# HISTORIC LANDMARK COMMISSION

## STAFF REPORT

**Trudell/Thompson Window Replacement  
PLNHLC2010-00057  
249 South 1100 East  
May 5, 2010**

**Exhibit F –  
Photos – South Facade**

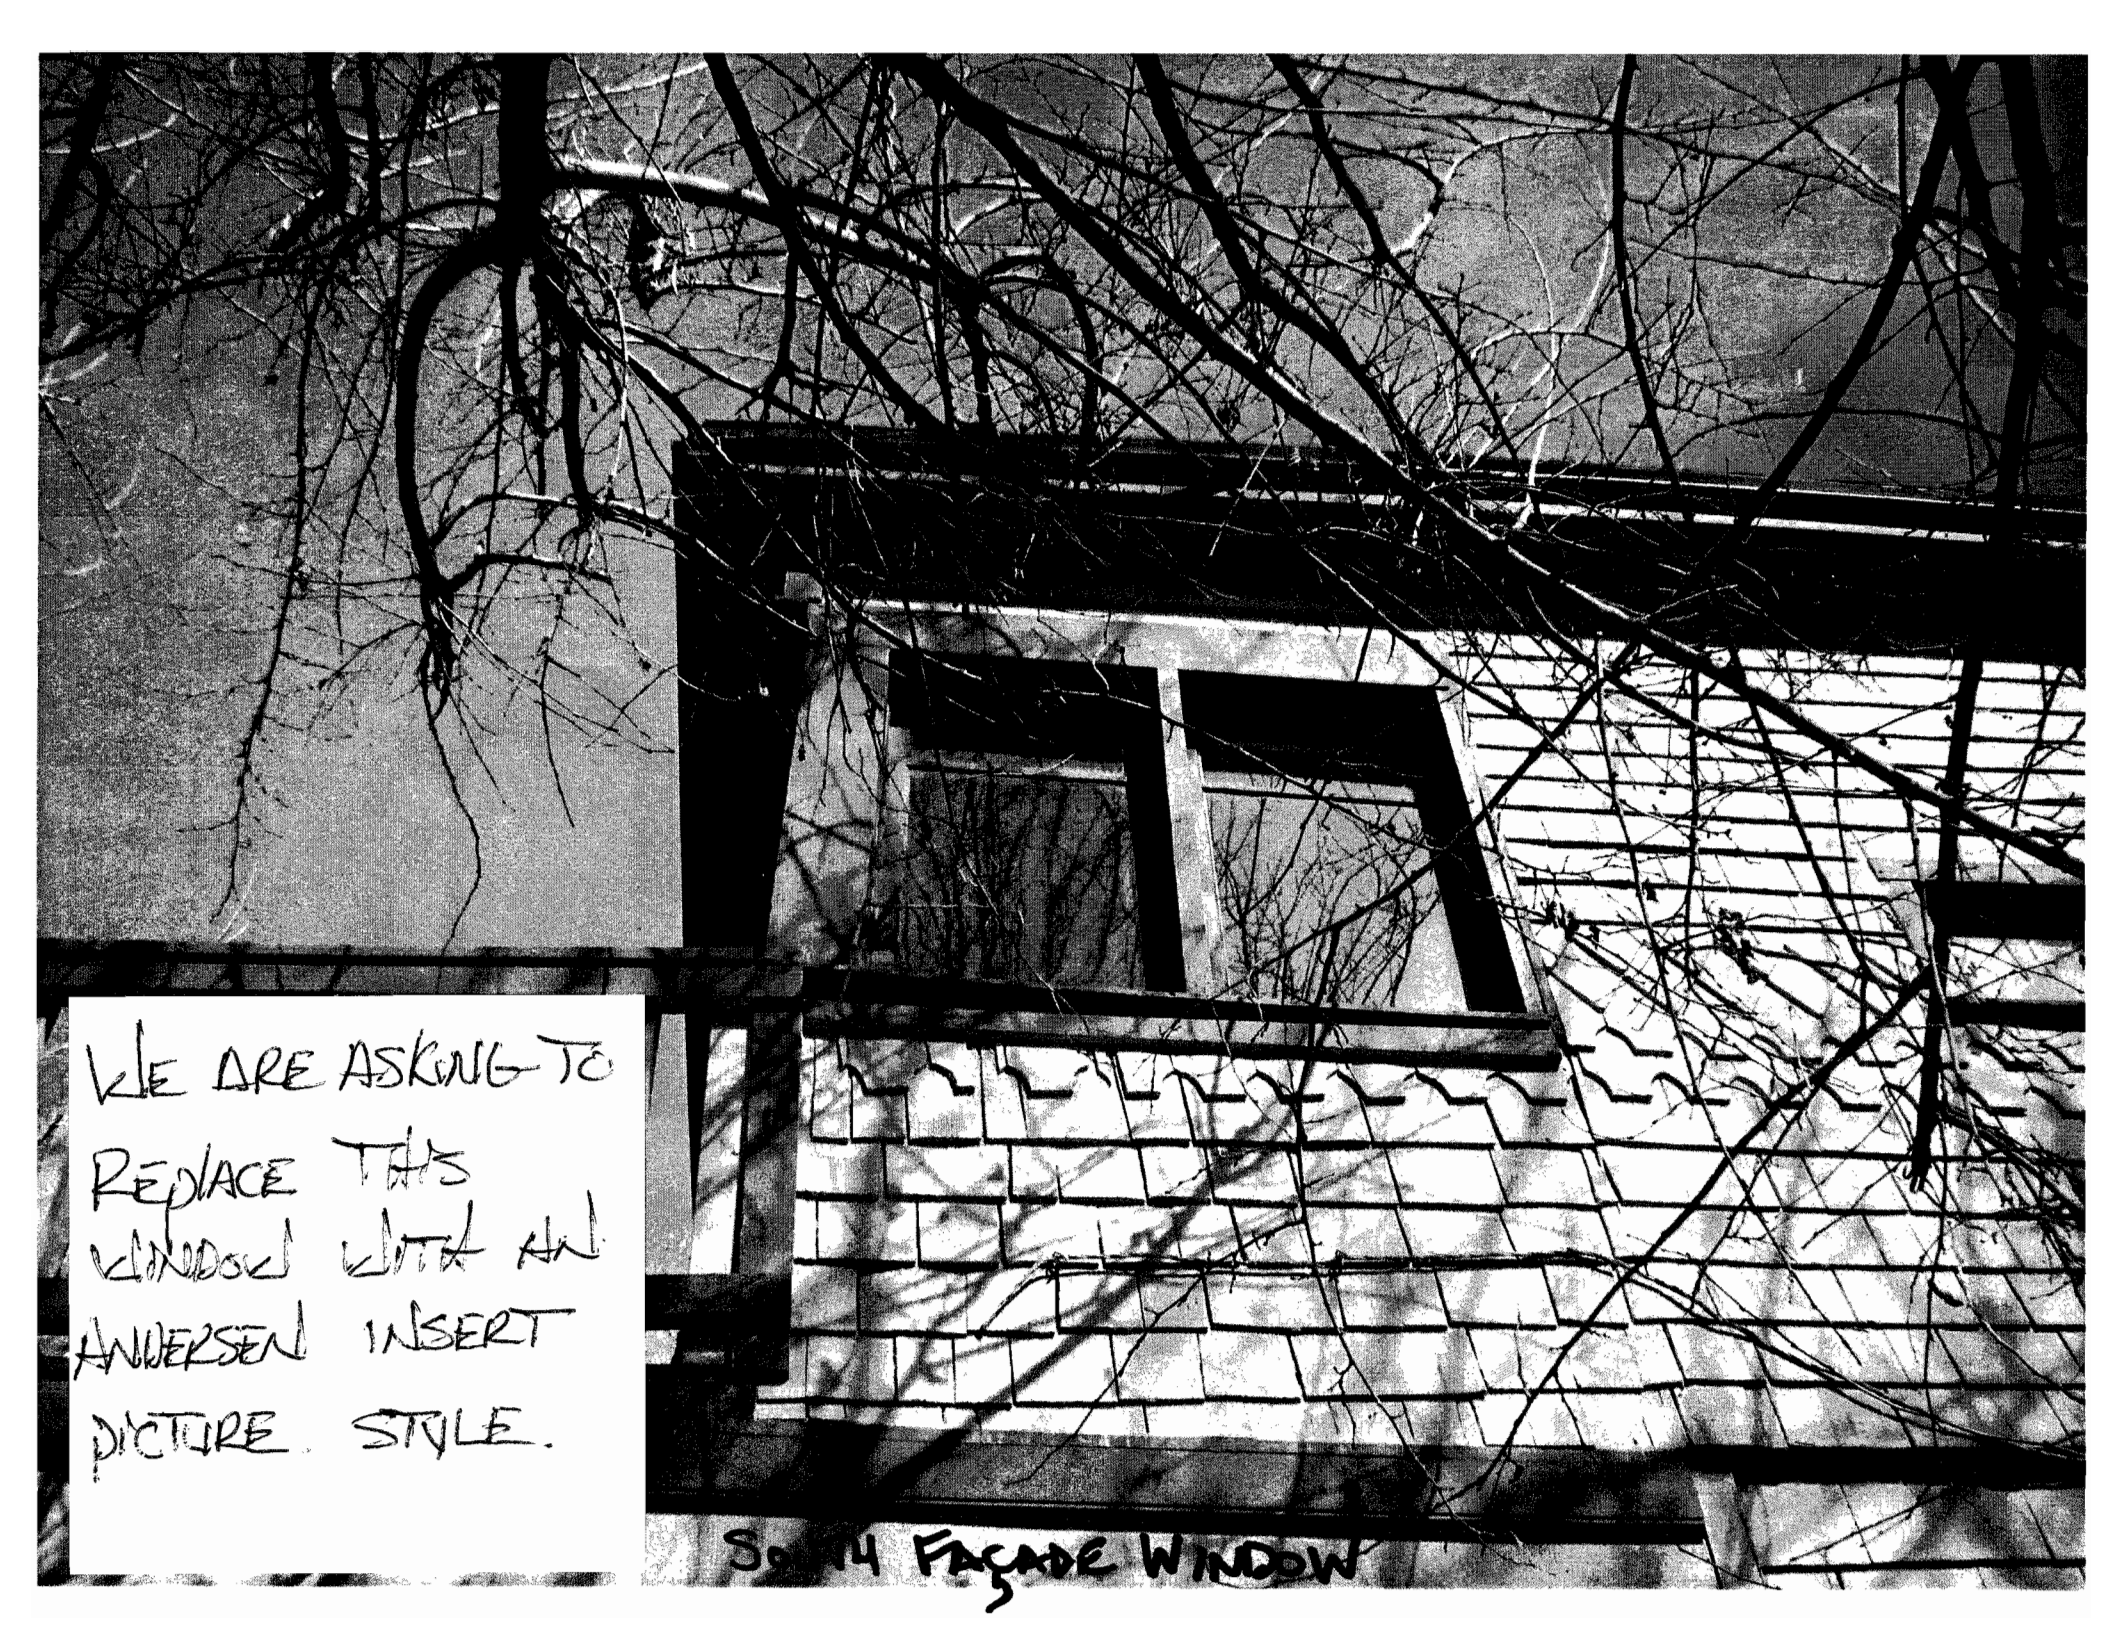
**Discussion for Standards 4, 5, and 6 in relation to the south façade windows:** From the photographs submitted (Exhibit F) and a site inspection, the existing windows appear to be repairable and are character defining features of the building. The windows on this façade, proposed for replacement, are wood windows of the casement and single-hung varieties. While these windows may not be original, they are certainly older windows and contribute to the historic character of the home. These windows appear to have acquired historic significance in their own right and therefore should be retained and preserved. They display distinctive features and construction techniques, and are examples of craftsmanship that characterize a historic property. Planning Staff contends that these windows are not beyond repair and therefore should be preserved and maintained, rather than replaced.

If the Historic Landmark Commission makes the determination that it is appropriate to replace these windows rather than repair them, Planning Staff suggests that a picture window is not an appropriate replacement style for the wood casement windows on the upper-level, and that the single-hung windows on the ground level be replaced with single or double-hung windows with a substantial mullion and no grid pattern.

**Finding for Standards 4, 5 and 6 in relation to the south façade windows::** Replacement of the wood windows on the south façade of the home does not meet Standards 4, 5, and 6, nor the applicable Design Guidelines and Criteria.

**Exhibit I –  
Anderson Door Diagram**

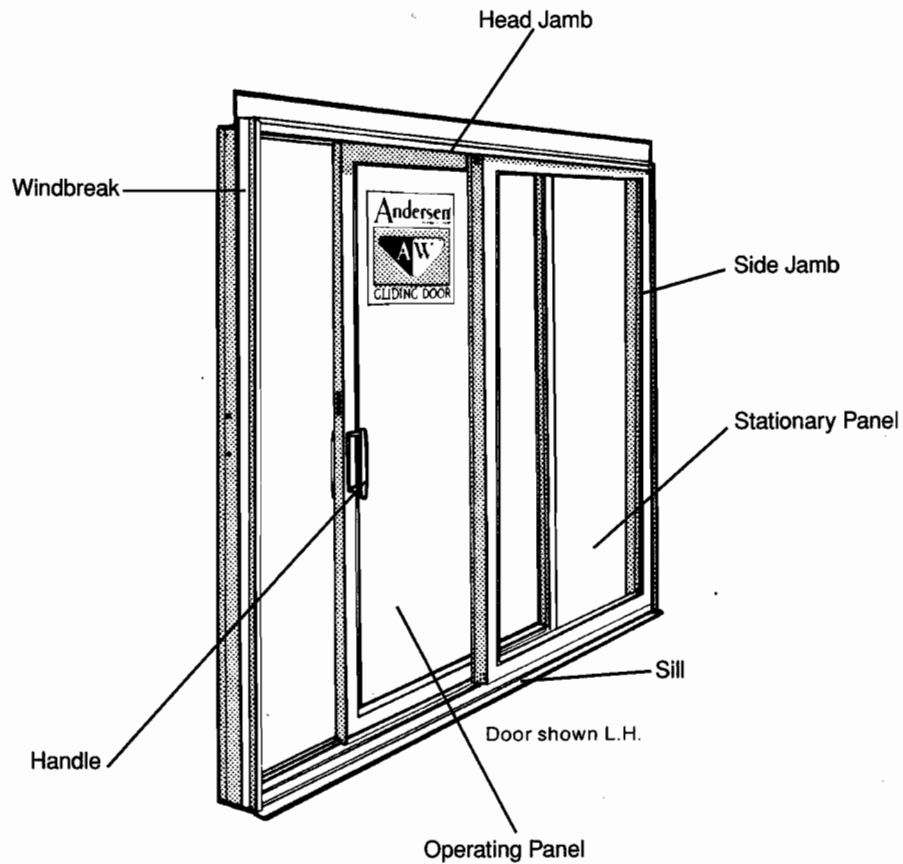
Of the extensive alterations that have occurred on this home over the years, the alterations to the front façade are the most significant. The installation of a sliding glass door has no relevant context in the historic integrity of this home. Sliding doors of this nature did not exist in 1895 when the home was built.

**Discussion for Standard 2:** There is no way to determine if a doorway was ever originally in the home in this particular location; what the opening size may have been, or what any original door may have looked like, due to the fact that this was once an interior portion of the house. Therefore, it is impossible to make a determination of what a replacement door should be, based on what may have been there originally.

While Planning Staff concurs that the replacement of this door would perhaps be a visual improvement, Planning Staff asserts that a sliding glass door is inappropriate from a historic perspective. Planning Staff suggested the installation of a French door to replace the sliding door. A French door is more in keeping with the historic character and style of the home, and therefore more appropriate.

**Finding for Standard 2:** The replacement of the front façade sliding glass door with a like door is inappropriate, and does not retain, preserve, or contribute to the historic character of the property.
